PHILCO CORP.

MODELS 48-1000, 48-1000-5, 48-1050, 48-1050-5, CODE 125

Production Changes — Code 121

MODEL 48-1000, CODES 121,
125, PRODUCTION CHANGES

Figure 1. Focus and Beam-Bender Changes

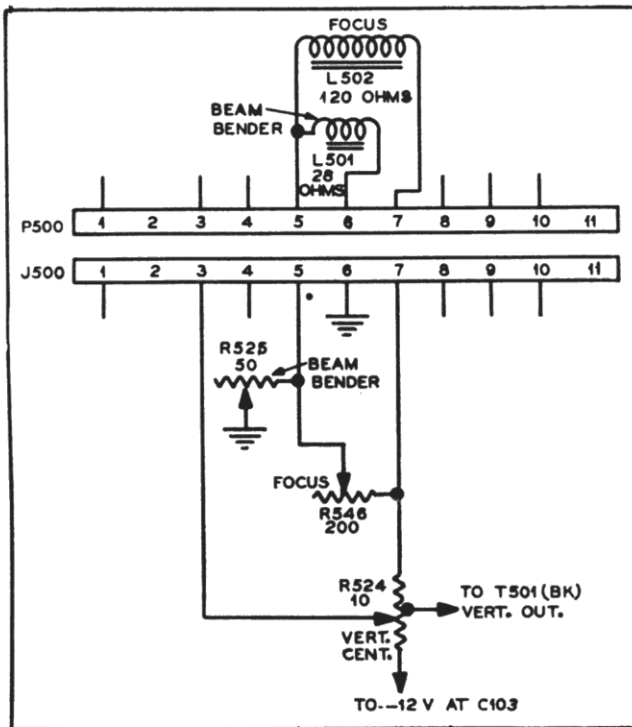
ITEM NO.	DESCRIPTION OF CHANGE	FIGURES OF PR-1103 AFFECTED	CHANGE EFFECTIVE	NEW OR ADDED PART NO.	OLD OR REMOVED PART NO.	REASON
1	R443 changed to 100,000 ohms.	17, 27	Run #1	66-4108540	66-5103340	To increase a-v-c stability.
2	R415 changed to 470,000 ohms.	17, 27	Run #1	66-4473340	66-5473340	To increase a-v-c stability.
3	R203 changed to 100,000 ohms.	18, 27	Run #1	66-4108540	66-3473340	To improve a-i-f performance.
4	R207 changed to 100,000 ohms.	18, 27	Run #1	66-4108540	66-3273340	To improve a-i-f performance.
5	L502 changed.	19, 27	Run #1	76-2622-2	76-2622	To improve focus. See figure 1.
6	R546 changed.	19, 27	Run #1	33-5547-2	33-5546-5	To improve focus. See figure 1.
7	L502 changed.	19, 27	Run #1	76-2622-1	76-2622	To improve focus. See figure 1.
8	R525 changed.	19, 27	Run #1	33-5546-4	33-5546-2	To improve focus. See figure 1.
9	R545 removed.	19, 27	Run #1		66-3105340	To improve focus. See figure 1.

Figure 2. Horizontal-Sweep Changes

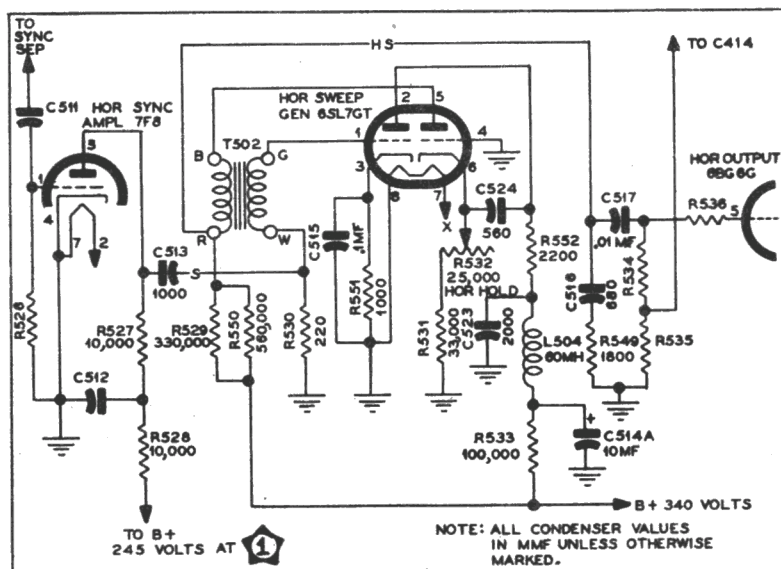
25	R532 changed to 25,000 pot. and rewired as in figure 2.	19, 26, 27	Run #6 and #7	33-5539-28	33-5539-13	To improve horizontal-sync stability.
26	R533 changed to 100,000 ohms and rewired as in figure 2.	19, 26, 27	Run #6 and #7	66-4103340*	66-4393340*	To improve horizontal-sync stability.
27	R549 changed to 1800 ohms.	19, 26, 27	Run #6 and #7	66-2183340*	66-2223340*	To improve horizontal-sync stability.
28	R550, 560,000 ohms, added as in figure 2.	19, 26, 27	Run #6 and #7	66-4563340*		To improve horizontal-sync stability.
29	R551, 1000 ohms, added as in figure 2.	19, 26, 27	Run #6 and #7	66-2103340*		To improve horizontal-sync stability.
30	R552, 2200 ohms, added as in figure 2.	19, 26, 27	Run #6 and #7	66-2223340*		To improve horizontal-sync stability.
31	C514A rewired as in figure 2.	19, 26, 27	Run #6 and #7	No change		To improve horizontal-sync stability.
32	C515 changed to .1 mf. and rewired as in figure 2.	19, 26, 27	Run #6 and #7	61-0113*	60-10825401*	To improve horizontal-sync stability.

33	C516 changed to 680 mmf. and rewired as in figure 2.	19, 26, 27	Run #6 and #7	60-10685401*	60-10825401*	To improve horizontal-sync stability.
34	C517 rewired as in figure 2.	19, 26, 27	Run #6 and #7	No change		To improve horizontal-sync stability.
35	C523, 2000 mmf., added as in figure 2.	19, 26, 27	Run #6 and #7	60-20205304*		To improve horizontal-sync stability.
36	C524, 560 mmf., added as in figure 2.	19, 26, 27	Run #6 and #7	60-10565314*		To improve horizontal-sync stability.
37	L504, 60 mh., added as in figure 2.	19, 26, 27	Run #6 and #7	32-4256		To improve horizontal-sync stability.
38	Wiring panel, four-point, added on bottom of chassis, parallel to sides of chassis, between vertical output (6K6GT) socket and C506.	19, 26, 27	Run #6 and #7	12W45661		To improve horizontal-sync stability.
39	R505 changed to 47,000 ohms.	19, 26, 27	Run #6 and #7	66-3473340*	66-4473340*	To improve horizontal-sync stability.

ITEM NO.	DESCRIPTION OF CHANGE	FIGURES OF PR-1103 AFFECTED	CHANGE EFFECTIVE	NEW OR ADDED PART NO.	OLD OR REMOVED PART NO.	REASON
1	Discriminator filament choke (L205) added at pin 4 of discriminator.	18, 27	Run #2	32-4112-4*		To reduce harmonic beat.
2	Z401 changed.	17, 27	Run #2	32-4213	32-4094	Slug tuning to aid in alignment.
3	Z402 changed.	17, 27	Run #2	32-4213-1	32-4094-1	Slug tuning to aid in alignment.
4	L503 changed.	19, 27	Run #3	32-4163-2	32-4163-1	To improve width adjustment.
5	Z202 changed.	18, 27	Run #4	32-4214	32-4101-1	To improve a-i-f stability.
6	5-mm.f. condenser (C223) added at pin 2 of 2nd a-i-f tube.	18, 27	Run #4	32-1224-5		To improve a-i-f stability.
7	L503 changed.	19, 27	Run #5	32-4163	32-4163-2	To improve width adjustment.
8	T503 changed.	19, 27	Run #5	32-8331	32-8305	To reduce high-voltage breakdown.
9	L503 changed.	19, 27	Run #6	32-4163-2	32-4163	
10	R528 rewired as in figure 2.	19, 26, 27	Run #7	No change		To improve horizontal-sync stability.

11	R529 changed to 330,000 ohms.	19, 26, 27	Run #7	66-4333340*	66-4103340*	To improve horizontal-sync stability.
12	R530 changed to 220 ohms.	19, 26, 27	Run #7	66-1223340*	66-2223340*	To improve horizontal-sync stability.
13	R531 changed to 33000 ohms and rewired as in figure 2.	19, 26, 27	Run #7	66-3333340*	66-4563340*	To improve horizontal-sync stability.
14	R532 changed to 25,000 pot. and rewired as in figure 2.	19, 26, 27	Run #7	33-5539-28	33-5539-13	To improve horizontal-sync stability.
15	R533 changed to 100,000 ohms and rewired as in figure 2.	19, 26, 27	Run #7	66-4103340*	66-4393340*	To improve horizontal-sync stability.
16	R549 changed to 1800 ohms.	19, 26, 27	Run #7	66-2183340*	66-2223340*	To improve horizontal-sync stability.
17	R550, 560,000 ohms, added as in figure 2.	19, 26, 27	Run #7	66-4563340*		To improve horizontal-sync stability.
18	R551, 1000 ohms, added as in figure 2.	19, 26, 27	Run #7	66-2103340*		To improve horizontal-sync stability.

19	R552, 2200 ohms, added as in figure 2.	19, 26, 27	Run #7	66-2223340*		To improve horizontal-sync stability.
20	C514A rewired as in figure 2.	19, 26, 27	Run #7	No change		To improve horizontal-sync stability.
21	C515 changed to .1 mf. and rewired as in figure 2.	19, 26, 27	Run #7	61-0113*	60-10825401*	To improve horizontal-sync stability.
22	C516 changed to 680 mmf. and rewired as in figure 2.	19, 26, 27	Run #7	60-10685401*	60-10825401*	To improve horizontal-sync stability.
23	C517 rewired as in figure 2.	19, 26, 27	Run #7	No change		To improve horizontal-sync stability.
24	C523, 2000 mmf., added as in figure 2.	19, 26, 27	Run #7	60-20205304*		To improve horizontal-sync stability.
25	C524, 560 mmf., added as in figure 2.	19, 26, 27	Run #7	60-10565314*		To improve horizontal-sync stability.
26	L504, 60 mh., added as in figure 2.	19, 26, 27	Run #7	32-4256		To improve horizontal-sync stability.
27	Wiring panel, four-point, added on bottom of chassis parallel to sides of chassis, between vertical-output (6K6GT) socket and C506.	19, 26, 27	Run #7	12W45661		To improve horizontal-sync stability.
